REQUEST FOR TENDER (RFT 2023-01)

Addendum #2

2) Location 4: WA Day School Parking Lot Reconfiguration

WA Day Parking Lot Lots 6-9, Block 145, Plan 92B & Lots 6-9, Block 149, Plan 92B Town of Fort Macleod Conceptual Layout Concrete Asphalt Parking Lot (65 Stalls + 4 Handicap) Amenities Existing Title Lines

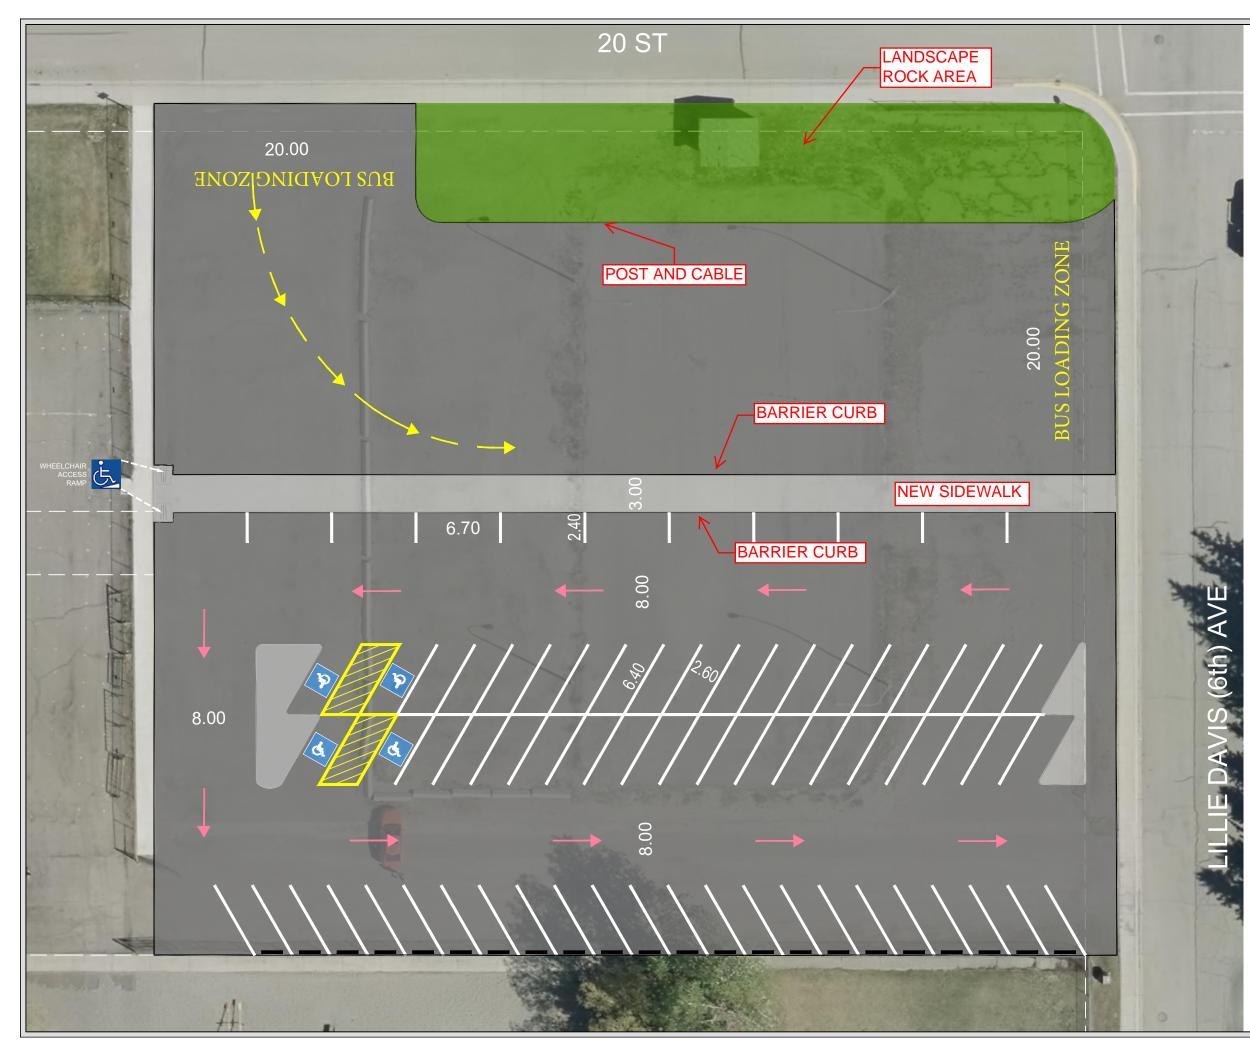
- a) Revised site plan is attached below.
- b) Questions (Town answers in red):
 - i. Where is the curb being installed and what type of curb? new curb is adjacent to the 3.0m sidewalk which runs east-west along the centre of the site. Curb type = barrier curb.
 - ii. Is regular parking lot paint acceptable or are you looking for something more heavy duty like thermoplastic? regular street paint is acceptable.
 - iii. Are the parking stall bumpers rubber or concrete? either type is acceptable, preference would be the more economical option.
 - iv. What is to be included in the line painting? line painting is as follows:
 - all parking stalls (i.e. parallel and angle) shown in white and yellow hatching
 - directional arrows in car parking area. Colour = white.
 - Bus loading area "bus loading zone" text shown on revised plan. Colour = yellow
